Comments for EPPR-10-14e of EVAP

Tianjin Motorcycle Technical
Center (TMTC)
2015.06

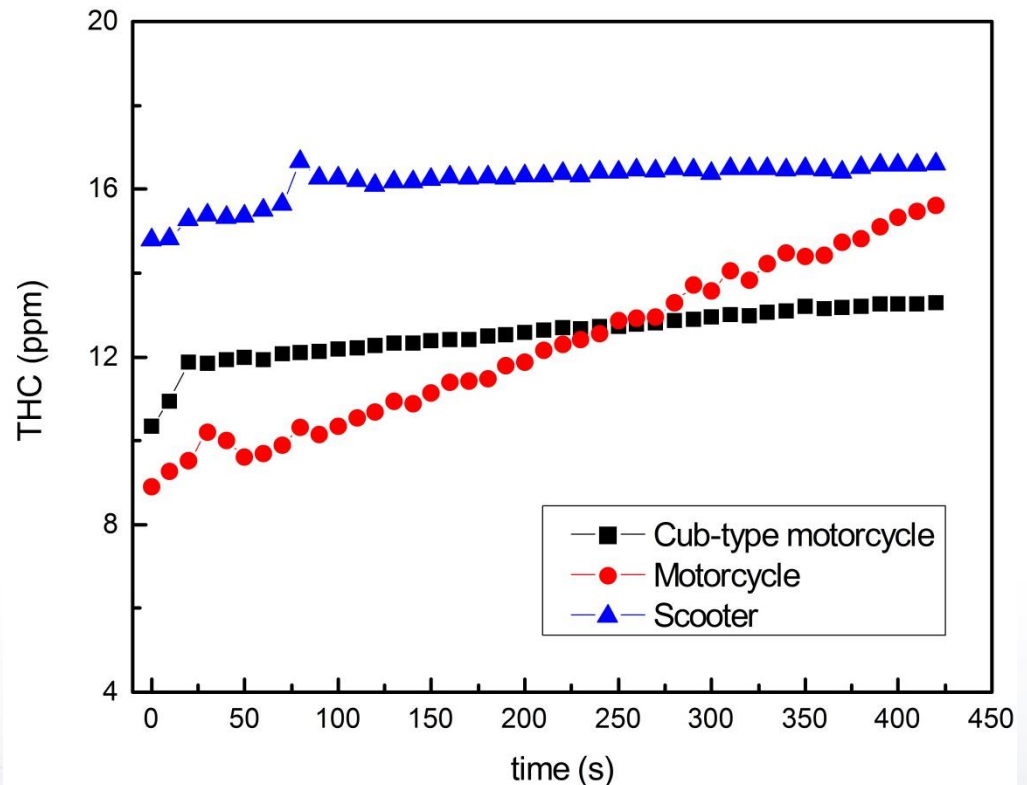
- 4.3.3. The level of evaporative emissions is determined by the measurement of hydrocarbon emissions over a 60-minute hot soak period. The hot soak test shall begin within seven minutes of the completion of the driving cycle specified in point 4.3.2.1.
- Proposal
 - 4.3.3. The level of evaporative emissions is determined by the measurement of hydrocarbon emissions over a 60-minute hot soak period. The hot soak test shall begin within seven minutes of the completion of the driving cycle specified in point 4.3.2.1 and within two minutes of engine shutdown.

The figure shows that the THC concentration of different motorcycles evaporate from 10s to 420s after engine stopping.

During this period, the evaporation of the motorcycle will affect the test results of Hot Sock test.
